Access Compliance Report Public Rights-of-Way (Curb Ramps)

Main Street: SANTA_ANA_AVE Cross Street: MESA_DR Location: NW

ADA ID: RPAT220128171746 Ramp Type: Type 1 - Perpendicular Diagonal Initial Pass/Fail: Pass Overall Compliance: No Severity Score: 6

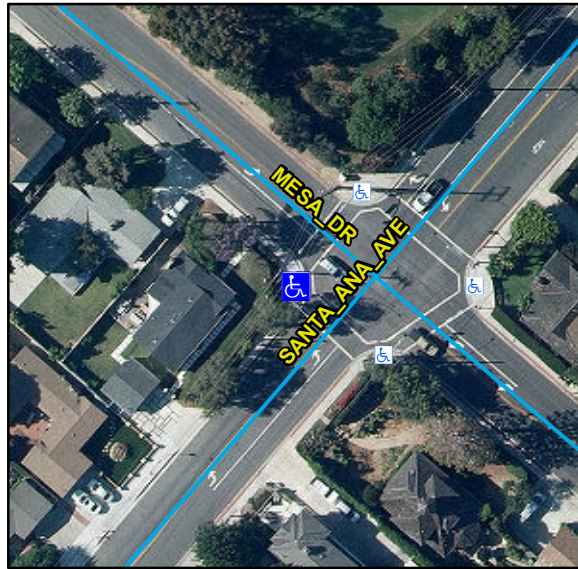
Remove & Replace Curb Ramp With Two New Directional Ramps or Equivalent. Remove & Replace Gutter. Utility Present.

R304.2.1, R304.5.3, R305.1.4, STD 1115
